⌘ **23.012 CR 015** ⌘ rev **3** ⌘ Current version: **5.2.0** ⌘

Title:	⌘ Addition of ADD feature		
Source:	⌘ Ericsson L.M., Siemens, Telefonica, T-mobile		
Work item code:	⌘ TEI6	Date:	⌘ 10/03/2004
Category:	⌘ B	Release:	⌘ Rel-6
	Use <u>one</u> of the following categories:		Use <u>one</u> of the following releases:
	F (correction)	2	(GSM Phase 2)
	A (corresponds to a correction in an earlier release)	R96	(Release 1996)
	B (addition of feature),	R97	(Release 1997)
	C (functional modification of feature)	R98	(Release 1998)
	D (editorial modification)	R99	(Release 1999)
	Detailed explanations of the above categories can be found in 3GPP TR 21.900 .		Rel-4 (Release 4)
			Rel-5 (Release 5)
			Rel-6 (Release 6)

Figure 4.1.3.1 (sheet 1 of 3): Process Update_Location_HLR

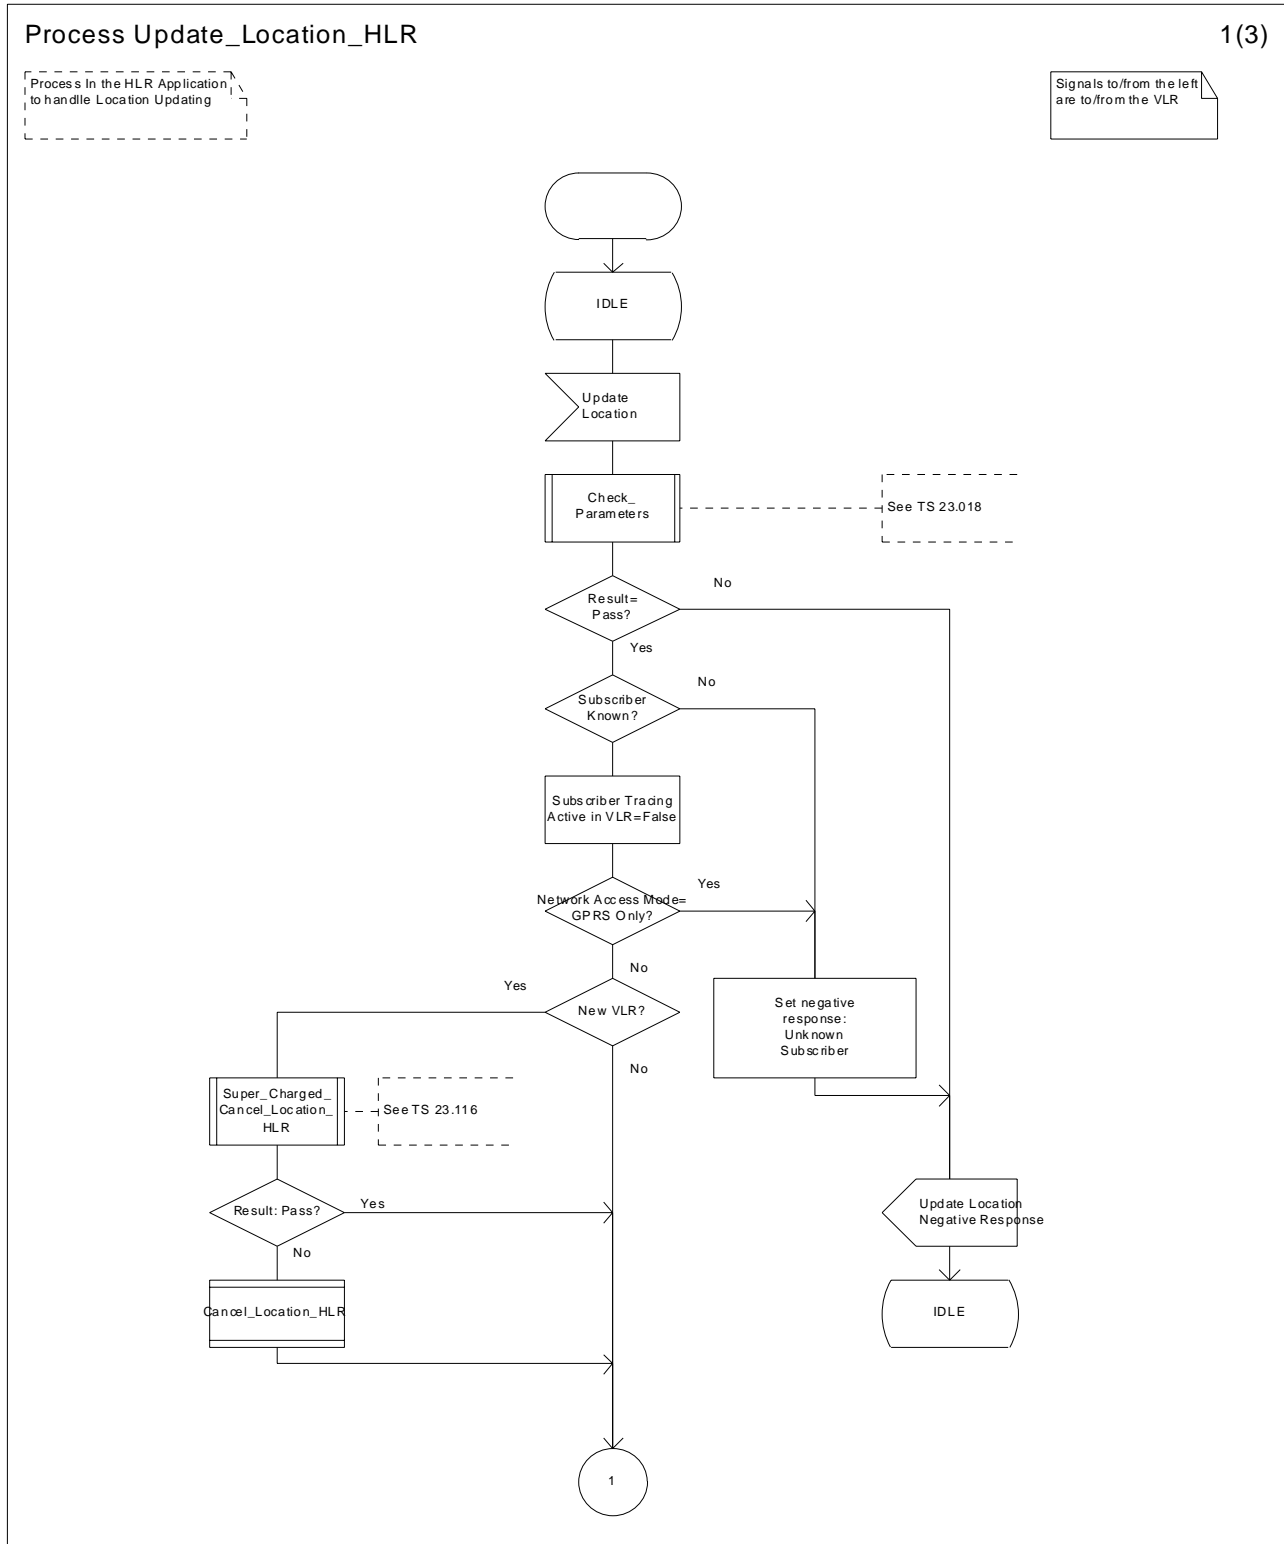
Sheet 1: The procedure Check_Parameters is specified in 3GPP TS 23.018 [5a].

Sheet 1: The procedure Super_Charged_Cancel_Location_HLR is specific to Super-Charger; it is specified in TS 23.116 [7]. If the previous VLR and the originating HLR support the Super-Charger functionality, processing continues from the "Yes" exit of the test "Result=Pass?".

Figure 4.1.3.1 (sheet 2 of 3): Process Update_Location_HLR

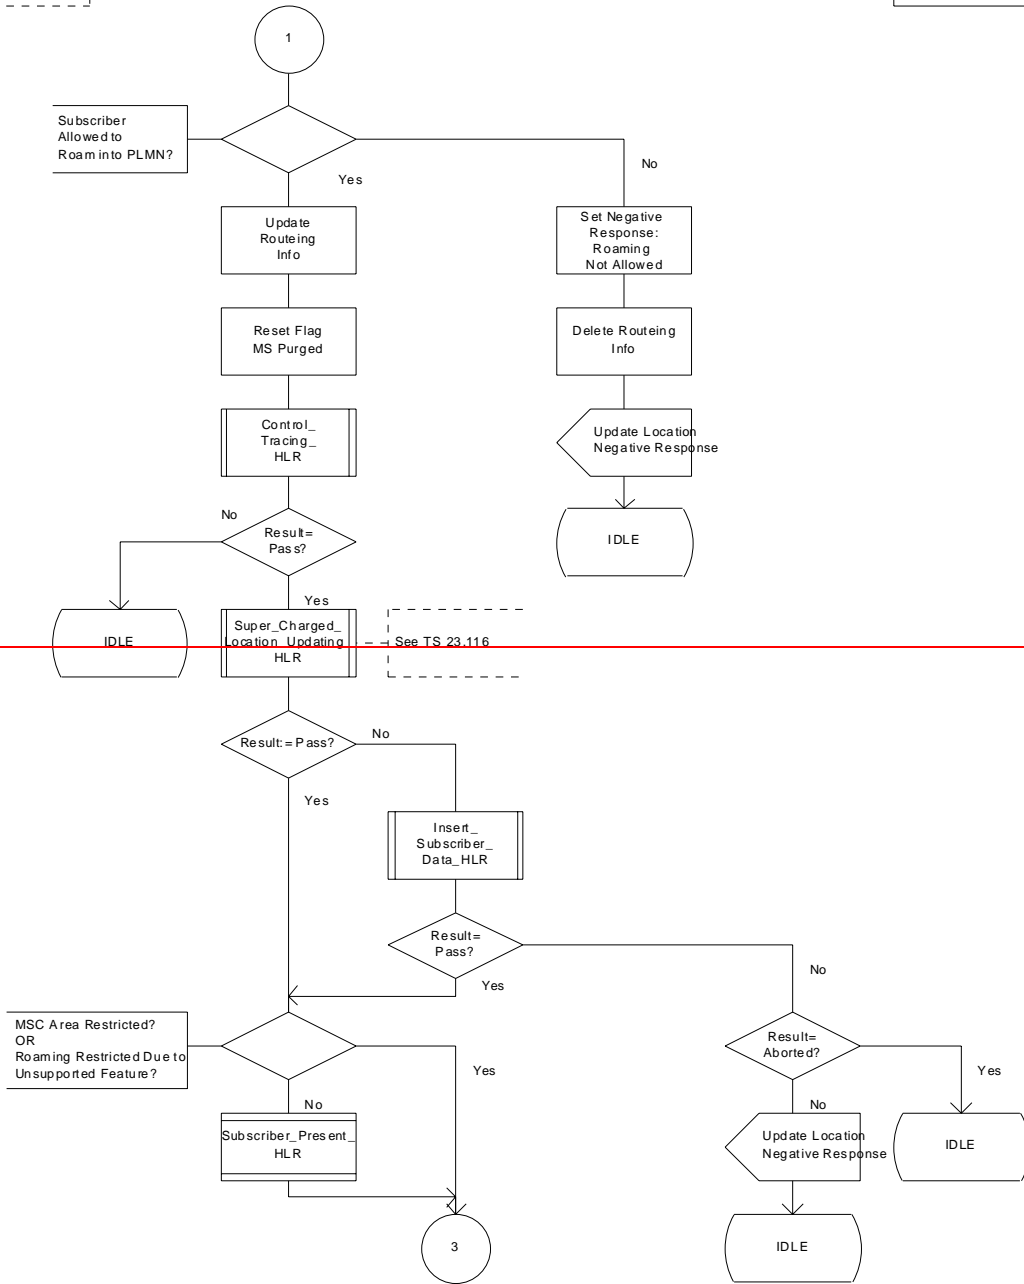
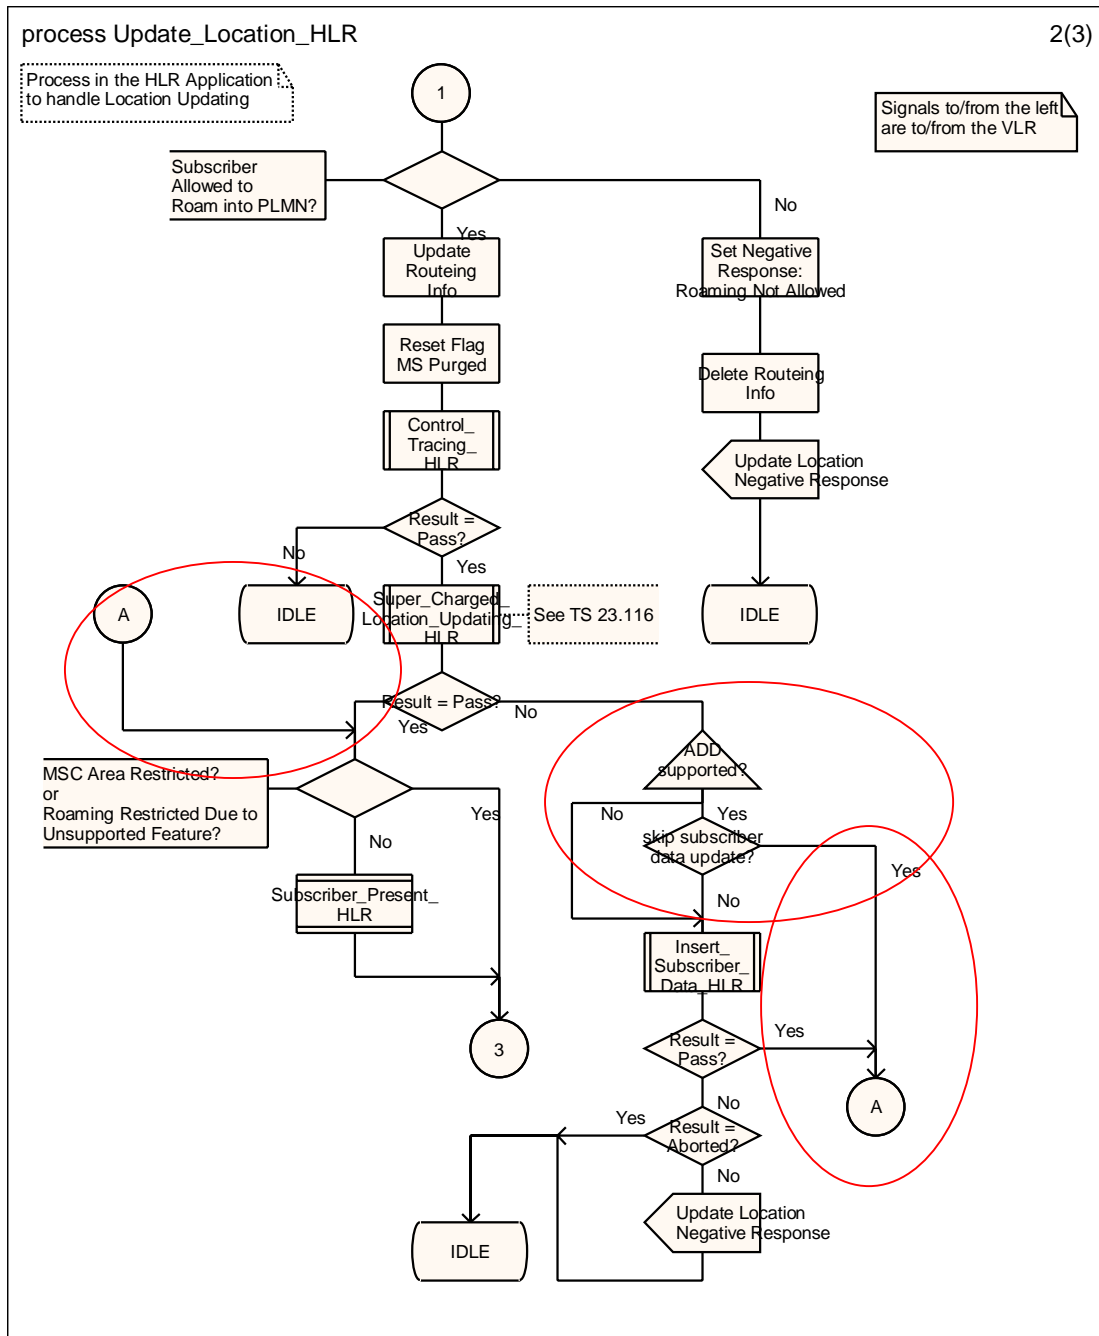
Sheet 2: The procedure Super_Charged_Location_Updating_HLR is specific to Super-Charger; it is specified in TS 23.116 [7]. If subscription data needs to be sent to the VLR, processing continues from the "No" exit of the test "Result=Pass?".

Sheet 2: The execution of the test "skip subscriber data update?" is optional and depends on the presence of the relevant indication from the VLR. If no indication is received, then the result of the test is "No".
